# UNITED STATES PATENT AND TRADEMARK OFFICE

APPLICATION NO.	FILING DATE	FIRST NAMED INVENTOR	ATTORNEY DOCKET NO.	CONFIRMATION NO.
10/517,602	07/08/2005	Wouter Van Praag	VANP3003/JJC/PMB	6667

<b>Office Action Summary</b>	<b>Application No.</b> 10/517,602	<b>Applicant(s)</b> VAN PRAAG ET AL.	
	<b>Examiner</b> ALEXANDER B. COMLEY	<b>Art Unit</b> 3746

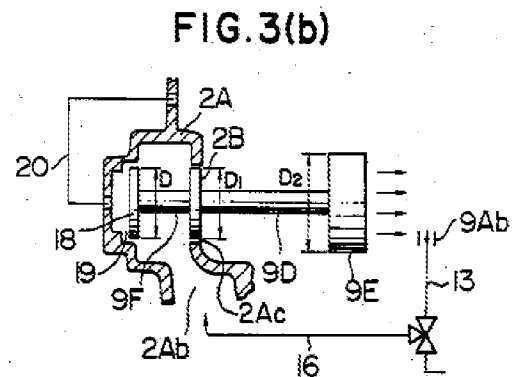
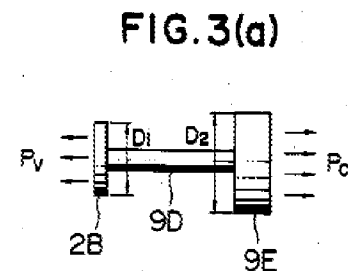
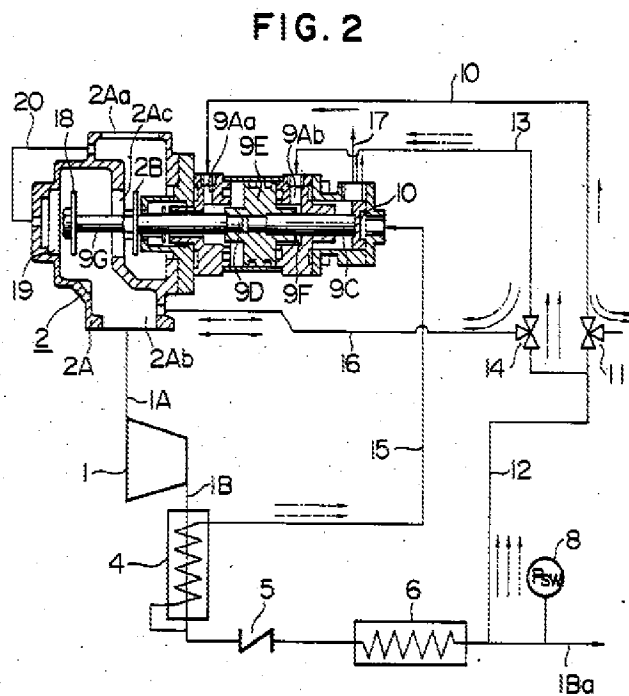
In regards to Independent **Claim 1**, and with particular reference to Figures 2, 3a, and 3b shown immediately above, **Suzuki (4,708,599)** discloses:

A compressor, containing a compressor element (1), and comprising a rotor chamber connected to an inlet pipe (1A) and an outlet pipe (1B); a reservoir in communication with the outlet pipe (1B); a pressure regulating system including an inlet valve (2) associated with the inlet pipe (1A); a piston (2B, 18) connected to the inlet valve (2) and which is movable in a cylinder (9F) to open and close the inlet valve (2) without the use of a spring acting on the piston (2B, 18); wherein the piston (2B, 18) is a double-acting piston which divides the cylinder (9F) into first (9Fa) and second (9Fb) closed cylinder chambers....the first cylinder chamber (9Fa), on a first side of the piston (2B, 18) facing away from the inlet valve (2), is connected to a part of the rotor chamber located near the inlet valve (2) via a first pipe (15), wherein the connection is always open; and on a second side of the piston (2B, 18), the second cylinder chamber (9Fb) is connected to a part of the rotor chamber situated near the inlet valve (2) and to the non-return valve (5) via a second pipe (1A)

As shown in the figures above, Suzuki discloses a rotary compressor system that is designed to smoothly and surely operate a suction valve of a compressor inlet without the use of a spring acting upon the valve member (i.e. piston). In particular, Suzuki first states "In another type of rotary compressor apparatus, on the contrary, the suction throttle valve means is always urged by a spring to be closed. In this type of rotary compressor apparatus, the compressor is started at no load, however, it takes a long time to open the suction throttle valve means against the urging spring. It has been proposed to provide a separate pressure source for the suction throttle valve means.

Suzuki’s device therefore utilizes a double-acting piston (2B, 18) to provide proper loading and unloading conditions for the compressor (See Column 5, Line 32 - Column 7, Line 26) Also, Suzuki’s piston divides the cylinder into two separate closed cylinders. In particular, Suzuki states “The cylinder 9A incorporates therein a gas release valve element 9B for opening and closing the gas release opening 9Ac, a rod 9C provided at one end thereof with the valve element 9B, a rod 9D provided at one end thereof with the valve element 2B and an unloader piston 9E dividing a working chamber 9F into two chamber sections 9Fa and 9Fb. The other ends of the rods 9C and 9D are connected to the opposite ends of the piston 9E, respectively. The piston 9E is closely fitted to and movable within the cylinder 9A.” (Column 2, Lines 38-48) Lastly, Suzuki’s device utilizes an always-open (i.e. no valving) first pipe 15 that connects one of the chambers to the rotor chamber, as well as a second pipe 1A that connects the opposing chamber to the rotor chamber (See Figure 2). However, although Suzuki discloses the majority of Applicant’s claimed invention, it fails to substantially and specifically disclose Applicant’s bridge setup.

FIG. 1

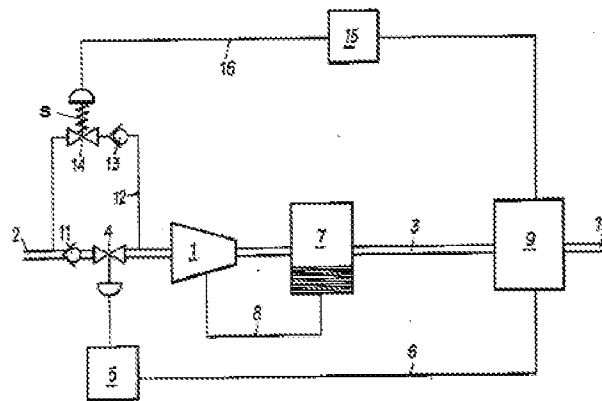
As seen in Figure 1 immediately above, UK Patent Application Publication to **Ott (GB 2,133,585)** teaches the remaining elements of Independent Claim 1 by disclosing a bridge bridging the inlet valve, a gas stream limiter, and a gas pipe. In particular, Ott discloses:

A bridge (12) bridging said inlet valve (4) and in which, between the inlet pipe (2) and the rotor chamber (1), are successively mounted a gas stream limiter (11) and a non-return valve (13) which only admits gas into the rotor chamber (1); a gas pipe (16) connecting the reservoir (9) to a part of the bridge (12) situated between the gas stream limiter (11) and the non-return valve (13); and a relief valve (14) associated with said gas pipe (16)

As can be seen in Figure 1 immediately above, Ott discloses an arrangement for controlling the loading and unloading of a screw compressor that is very similar to the system seen in Suzuki. Ott, however, further describes the piping arrangements and valve placements of the system that Suzuki fails to disclose. In particular, Ott discloses the use of a bypass line 12 (i.e. bridge) with a bypass valve 14 (i.e. relief valve) in order to properly throttle the amount of gas conveyed by the compressor. Ott goes on to

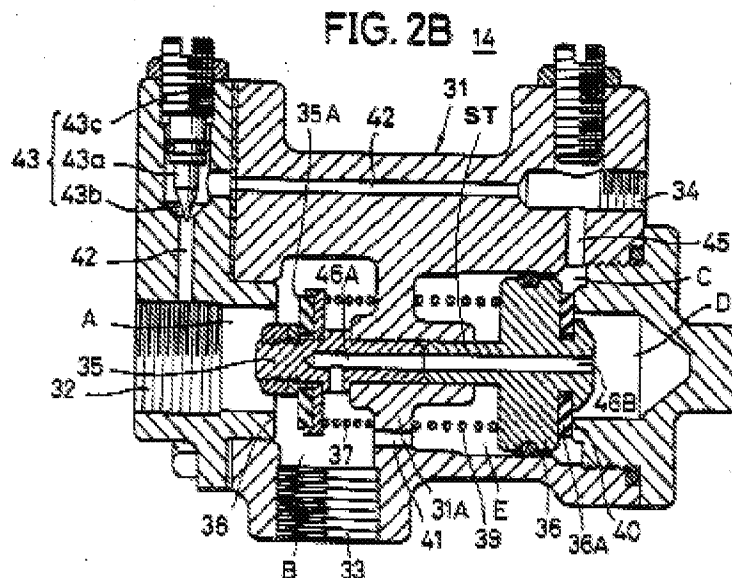
As shown in Figure 2B above, Tsuchida discloses a valve assembly comprising a duct provided throughout the length of the piston stem. In particular, Tsuchida discloses, "Relief passages 46A and 46B are respectively formed in the check valve 35 and the main valve 36, along the axial direction thereof." (Column 5, Lines 5-7) One of ordinary skill in the art of compressors could have easily utilized the stem duct of Tsuchida in combination with the valve of the Suzuki-Ott combination in order to obtain predictable results. Therefore, it would have been obvious to one of ordinary skill in the art of compressor capacity controls to modify the piston setup of the Suzuki-Ott combination with the stem-and-duct setup disclosed by Tsuchida in order to obtain predictable results; those results being a simplified connection between the piston and the inlet valve.

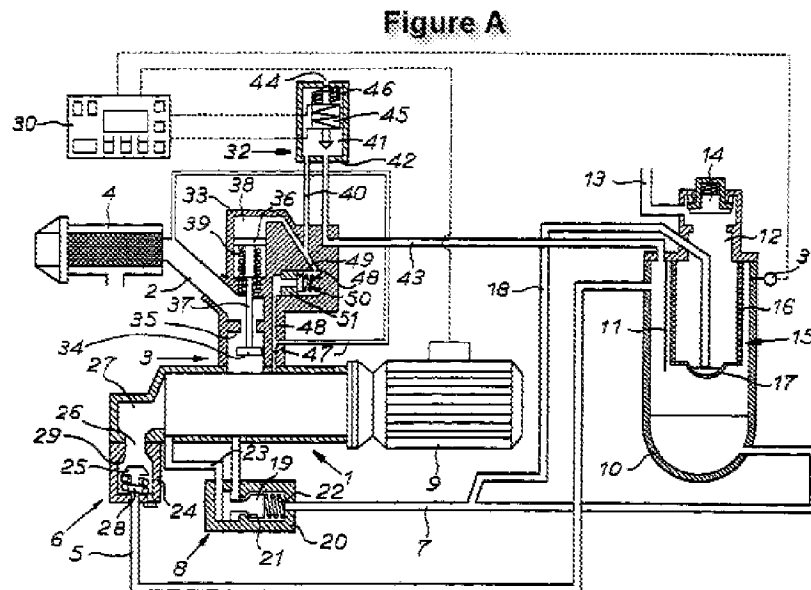
As shown in Figure A immediately above, the Coppens portion of the combination specifically discloses the specific use of electromagnetics for the control valve 32. It would have been obvious to one of skill in the art to utilize the techniques disclosed in the Suzuki-Ott combination in combination with those seen in the Coppens reference in order to obtain predictable results. One of ordinary skill in the art at the time of the invention could have easily applied the electromagnetic valving techniques of Coppens to the control valve of Ott in order to obtain predictable results; those results being a more reliable and better-controlled compressor system.
